sw stair floor 3

ne stair 4th floor

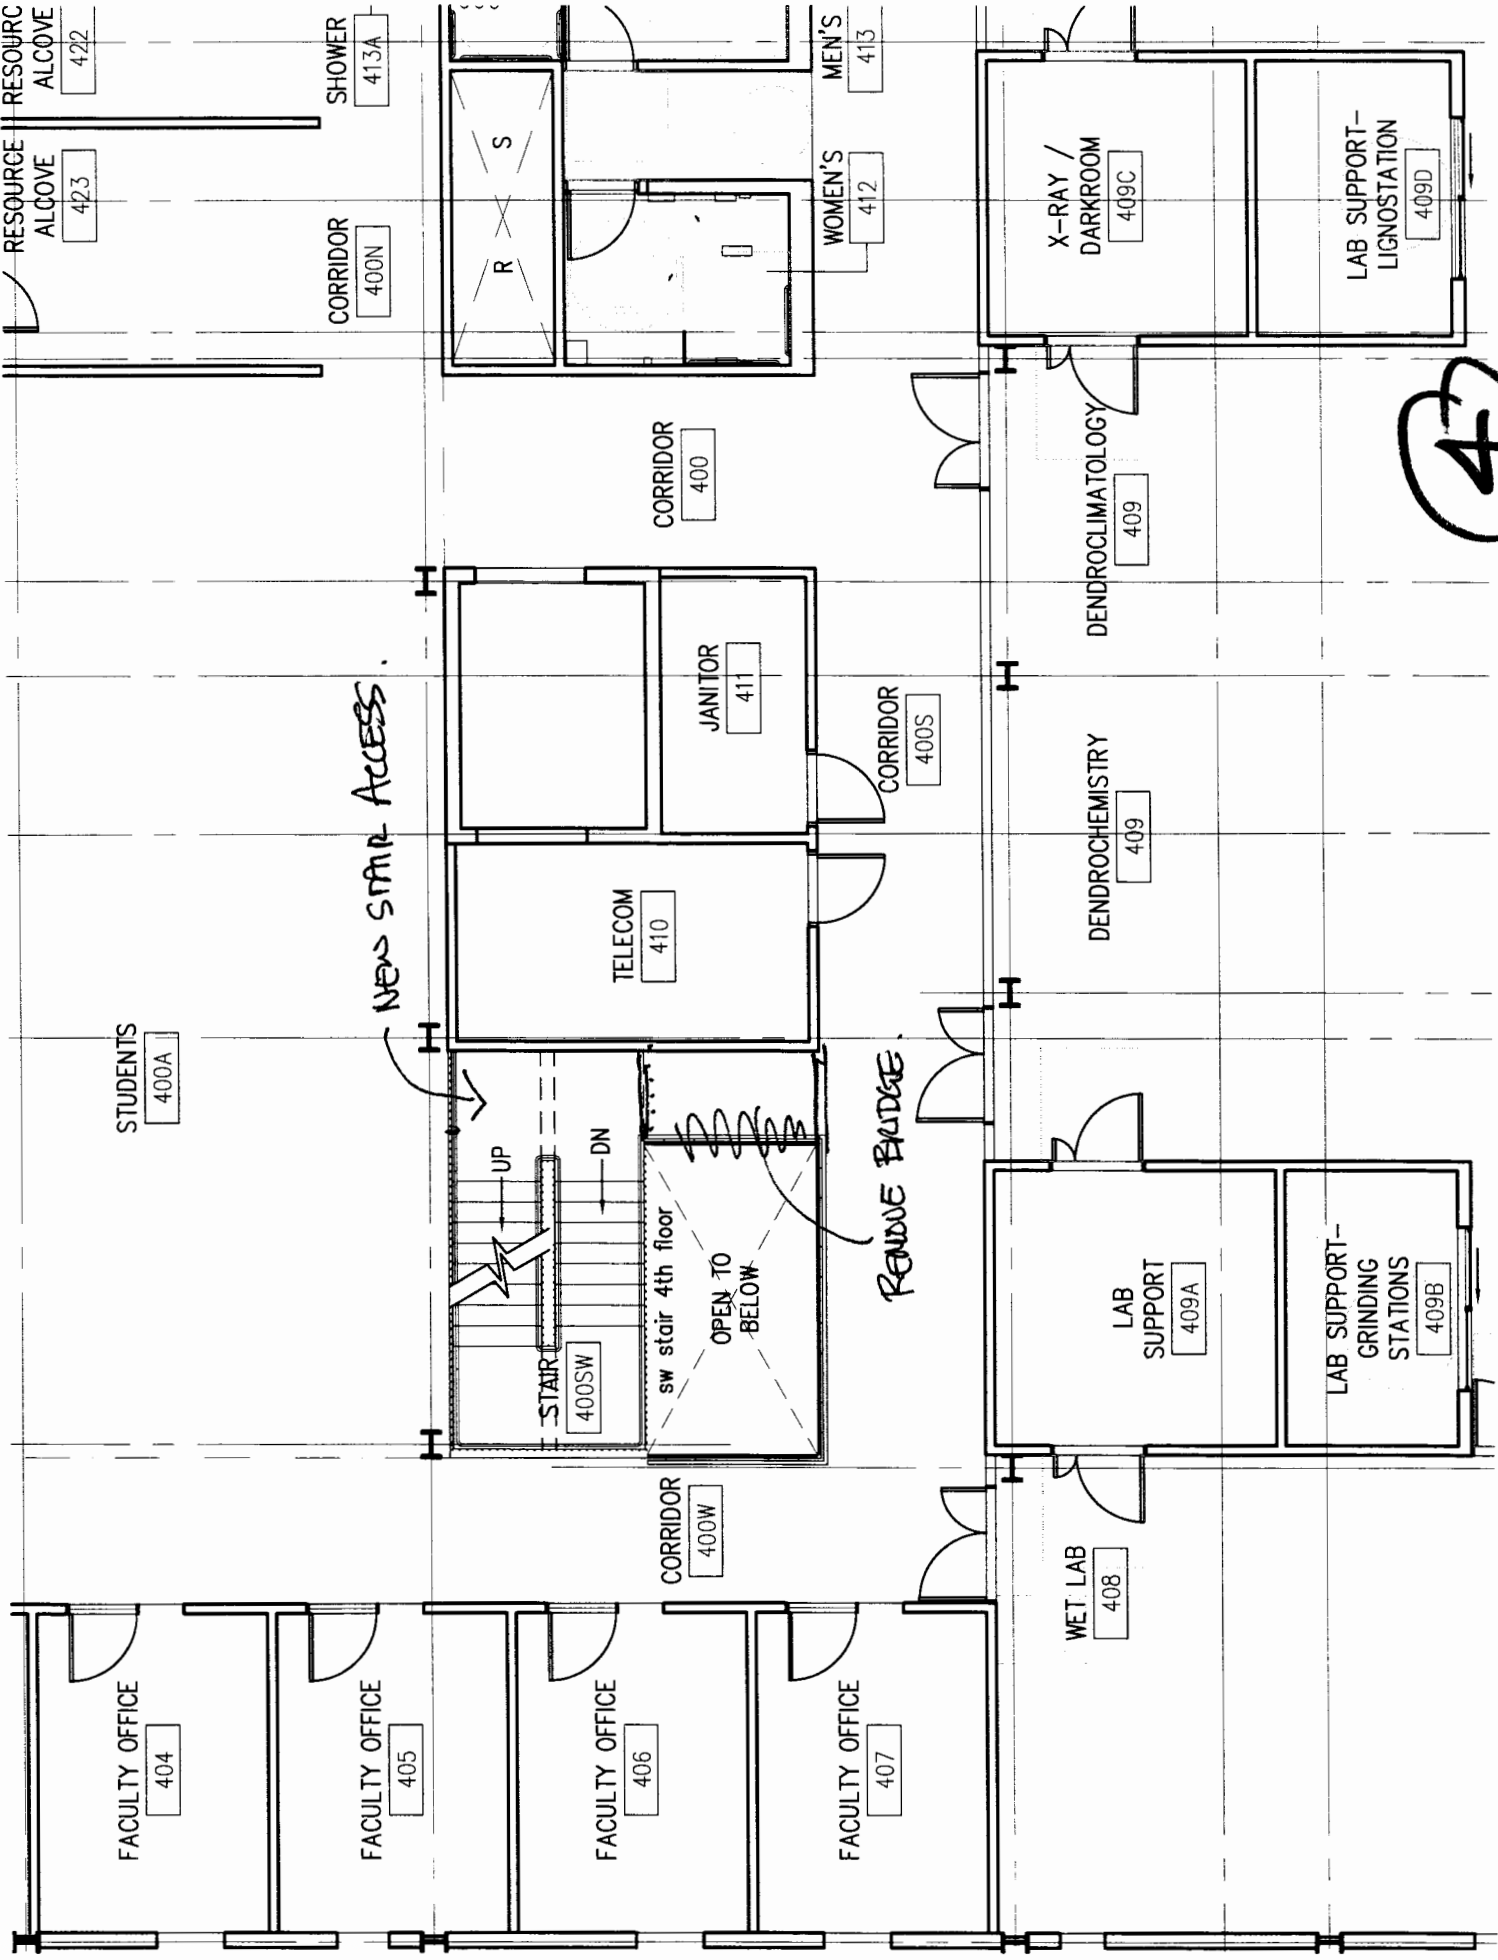
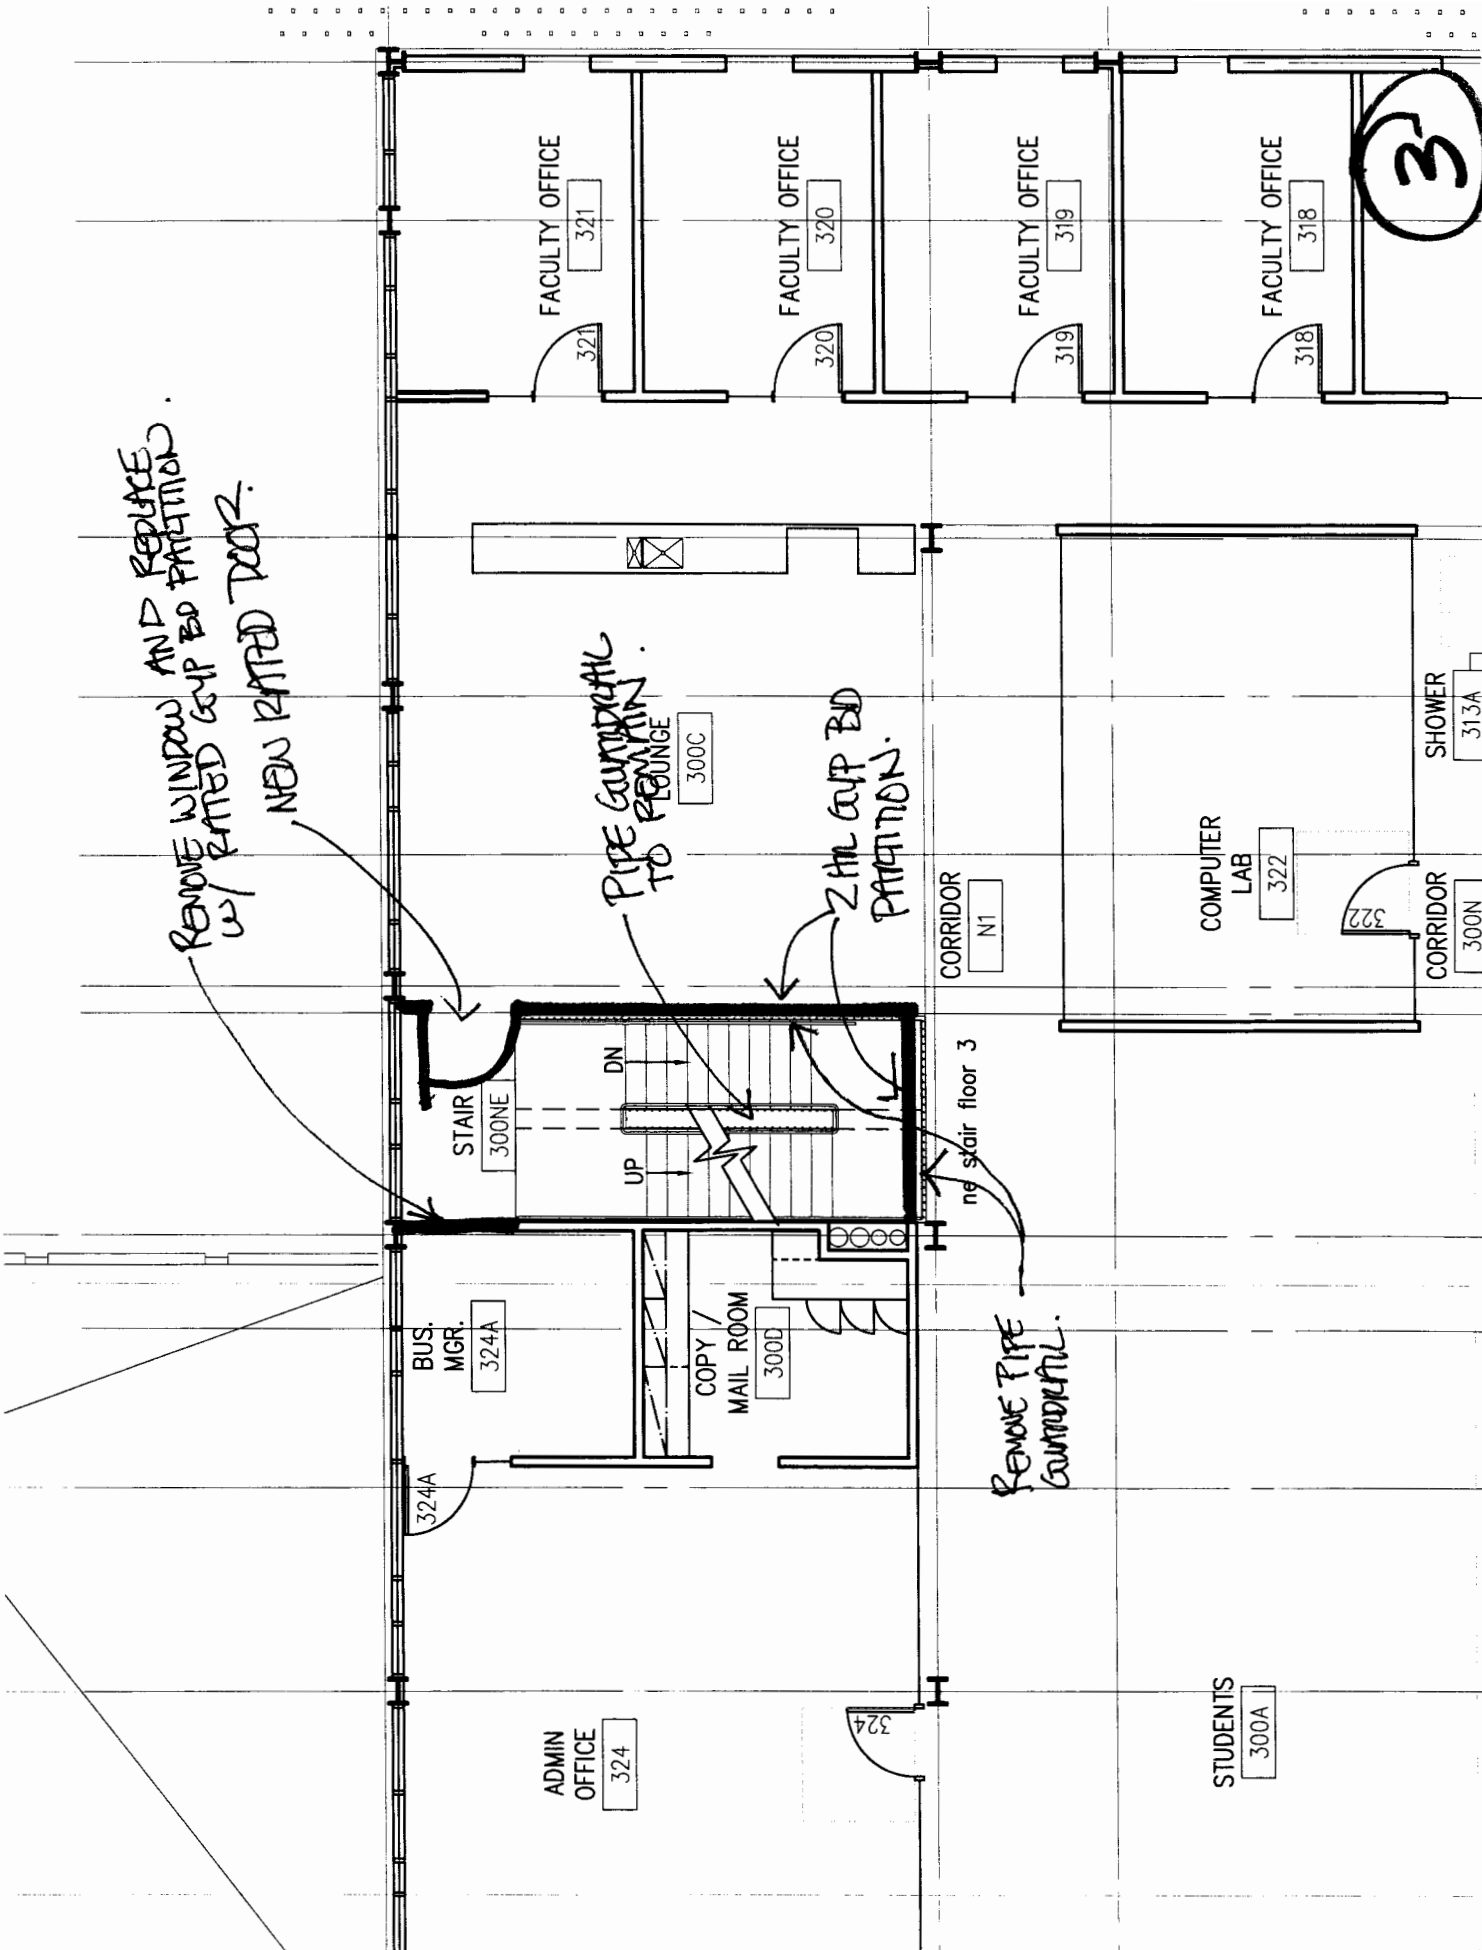
REMOVE WINDOW AND REDUCE
UP RATED GYP BD PARTITION.
NEW RATED DOOR.

PIPE COUNTERTOP
TO LOUNGE.

2 HL GYP BD
PARTITION.

REMOVE PIPE
COUNTERTOP.

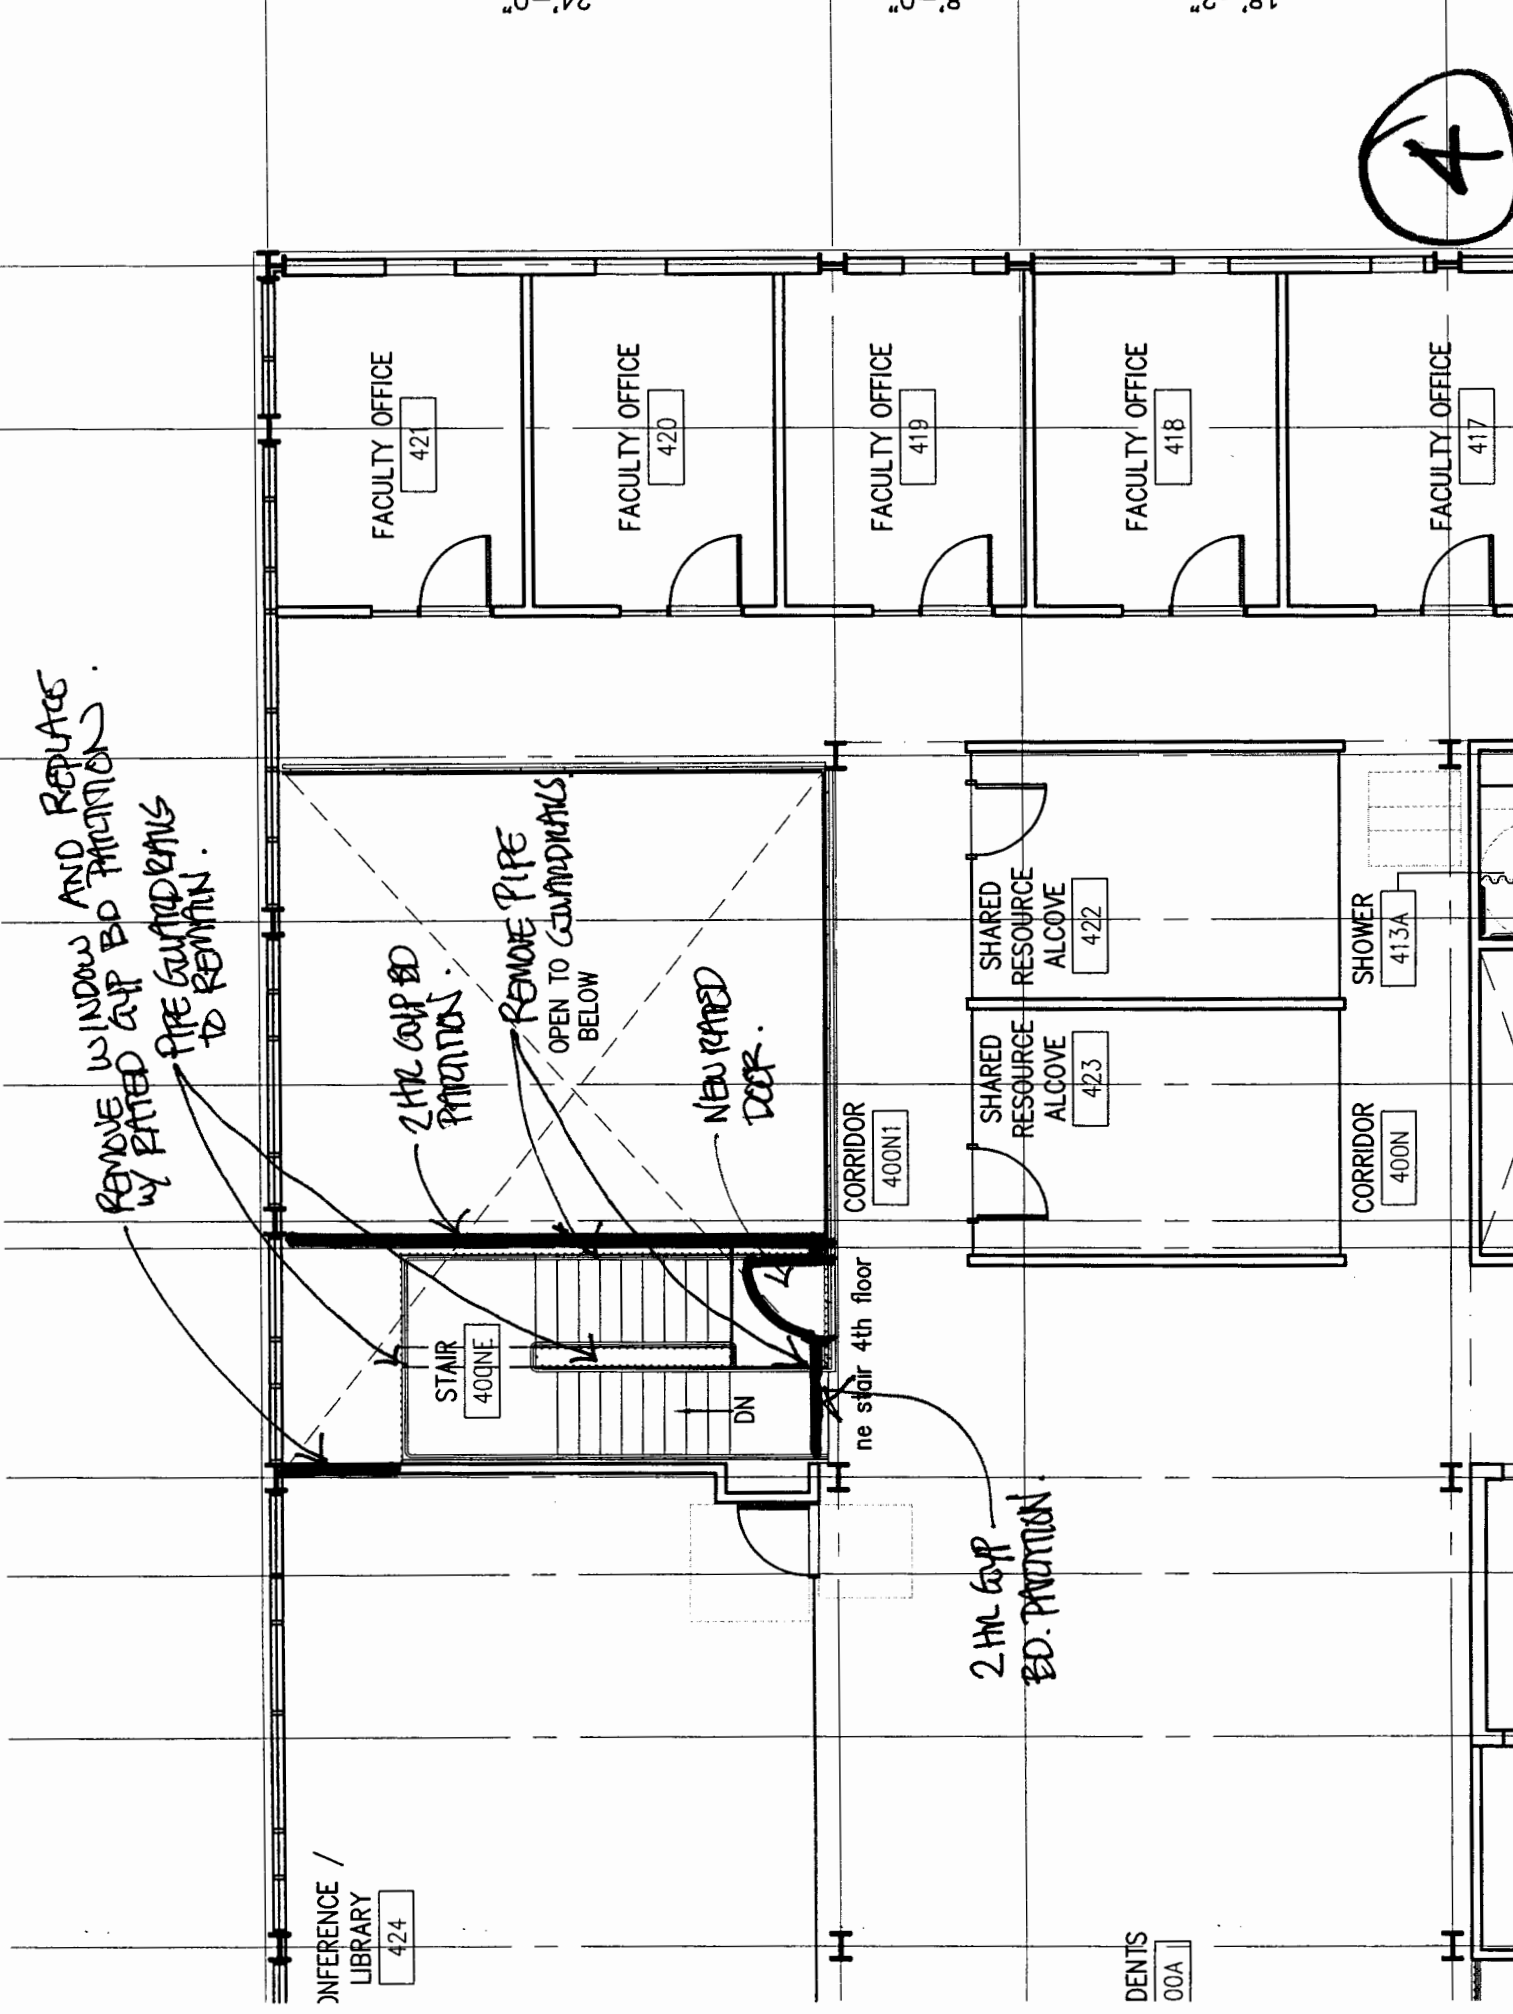
REMOVE WINDOWS AND REPLACE W/ RATED GWP ED. PARTITION.
 REMOVE FIRE GUATED RISKS TO REMAIN.

2 HL GWP ED. PARTITION.

REMOVE PIPE OPEN TO GROUND RISKS BELOW

NEW RATED DOOR.

2 HL GWP ED. PARTITION.
